APPLICATION NO.	FILING DATE	FIRST NAMED INVENTOR	ATTORNEY DOCKET NO.	CONFIRMATION NO.
10/671,086	09/25/2003	Charles W. Alvord	2003P88063 US	6320

Office Action Summary

DETAILED ACTION

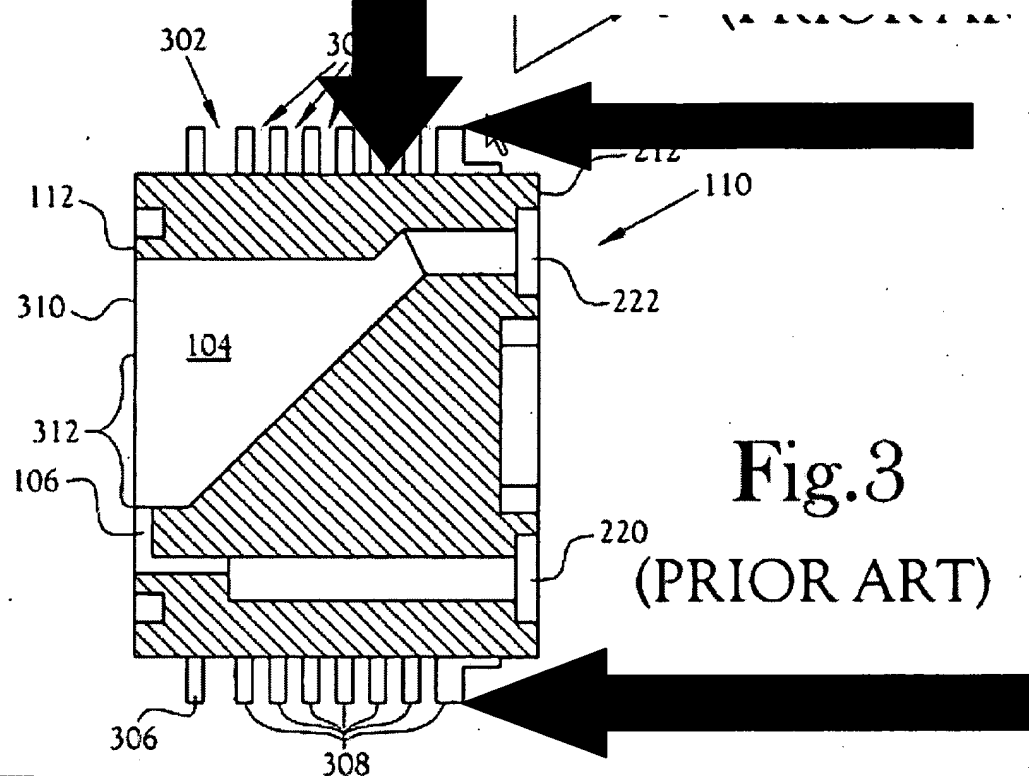
"Additionally, the prior art target assembly does not contain a cooling channel running along at least a portion of a sloped rear wall of a target chamber as claimed. It is particularly unclear and not understood how the Examiner reads this limitation on the prior art target assembly, and the Office action provides no detail as to how such limitation could possibly be interpreted to read on the prior art assembly as disclosed in Figs. 1-3. "

This limitation can be read in multiple ways:

First, channels 302, 304 are within the circumference of the target body, accordingly the vertical arrow in Fig 3 above indicates a portion of the cooling channel running along a portion of the sloped rear wall.

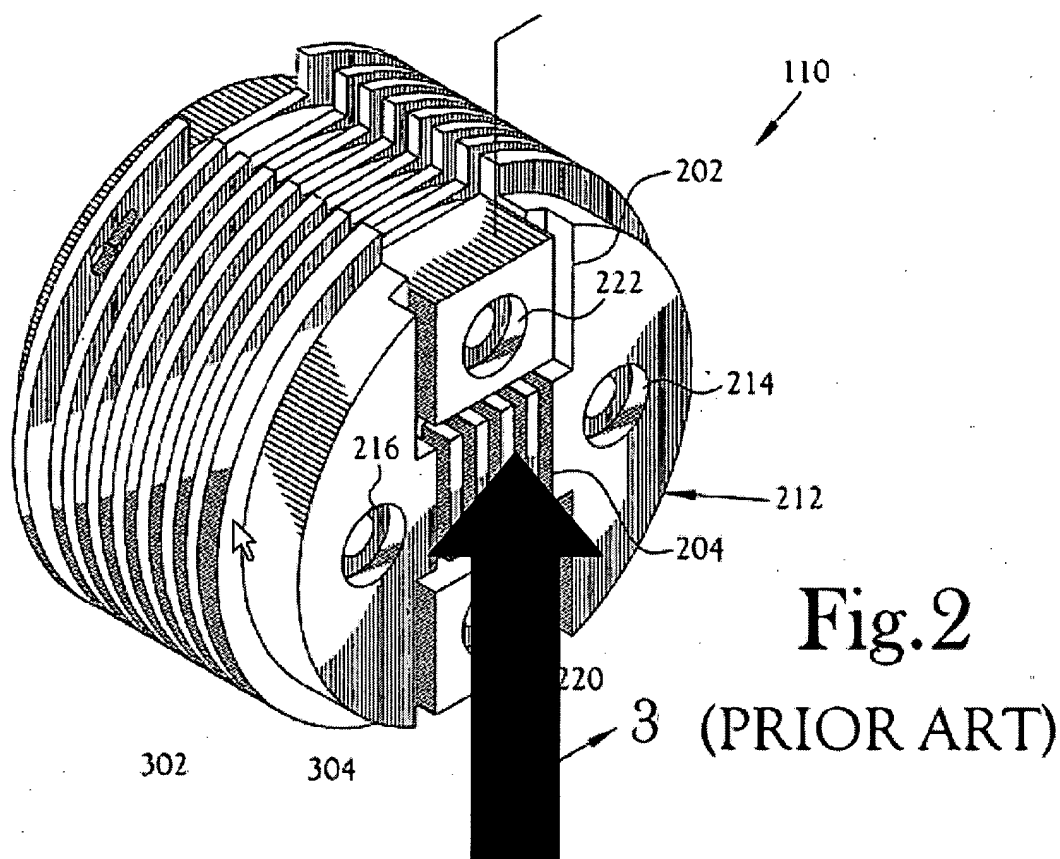
Second the back of the target also has cooling channels that run alongside a portion of the sloped rear wall as shown in Fig. 2 below.

Again, as previously expressed by the examiner, the cooling channels of the prior art run along at least a portion of the rear wall just as two lanes of a divided highway run along each other, since applicant has failed to set forth the metes and bounds of the limitations "running along at least a portion of said rear wall" the examiners assertions are correct.
